Service Bulletin

Bulletin No.: 10-06-01-008G

Subject: Engine Oil Consumption on Aluminum Block/Iron Block Engines with Active Fuel Management (AFM) (Install AFM Oil Deflector and Clean Carbon from Cylinder and/or Install Updated Valve Cover)

2740641

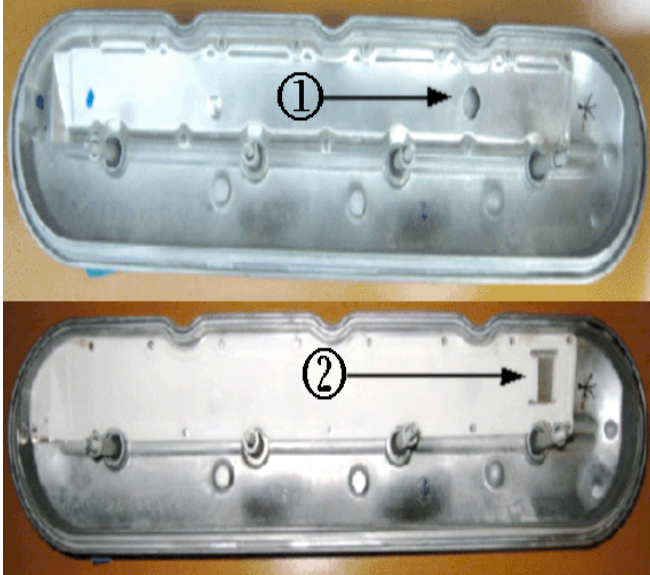
Aluminum or Cast Iron Block - Oil in Intake Manifold - Install Updated Valve Cover on All Models Built Prior to February 1, 2011

PCV pullover or an overactive lifter can cause oil to be pulled through the PCV system even at low vehicle mileage. A correctly functioning PCV system will only leave a film of oil in the intake manifold. Inspect the intake manifold to see if there is any oil puddling in the bottom. If there is you will need to replace the left valve cover. Two new left rocker arm covers have been released for trucks and vans. Technicians should replace the left rocker arm cover with GM P/N 12570427 for 2007-2008 or GM P/N 12642655 for 2009-2011. Refer to the Parts Information below for the Camaro. This rocker arm cover has a relocated PCV drain hole that prevents oil from entering the intake manifold. Refer to Valve Rocker Arm Cover Replacement - Left Side in SI.

Note: These rocker covers are for specific years. The PCV orifice is different for each. The correct cover must be used or an SES light may set.

- 1) Old Design
- 2) New Design

2474205

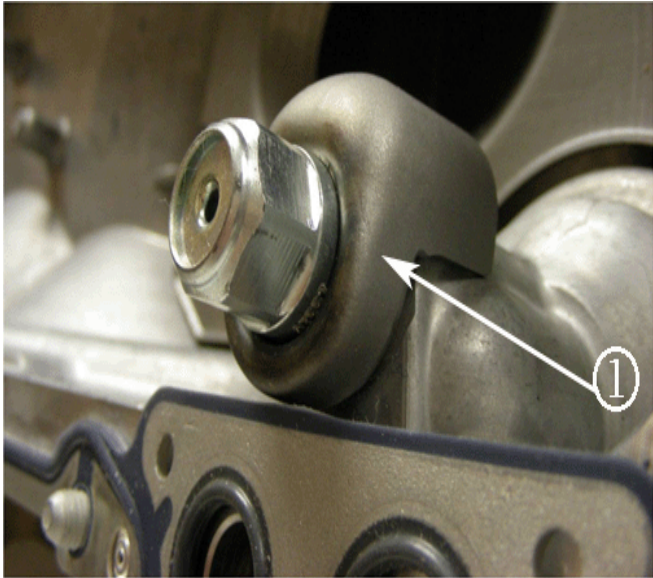
4. Remove the AFM valve (1).

2474207

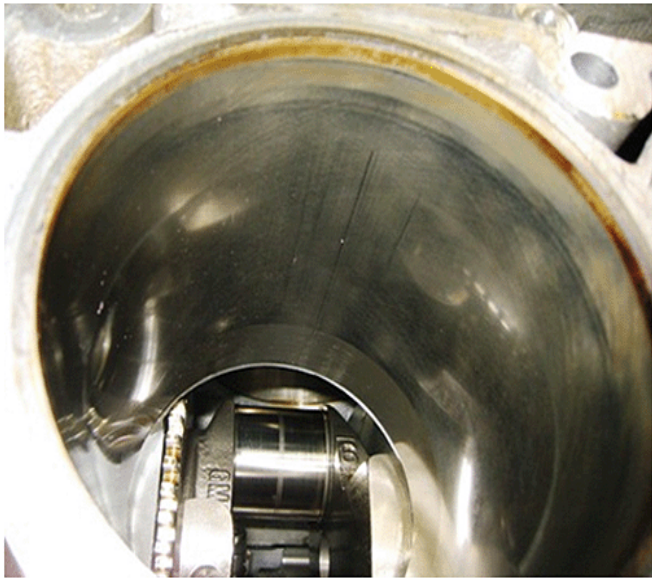
5. Install the new shield (1), GM P/N 12639759, and tighten the AFM valve to the oil pan to 28 N•m (20 lb ft).
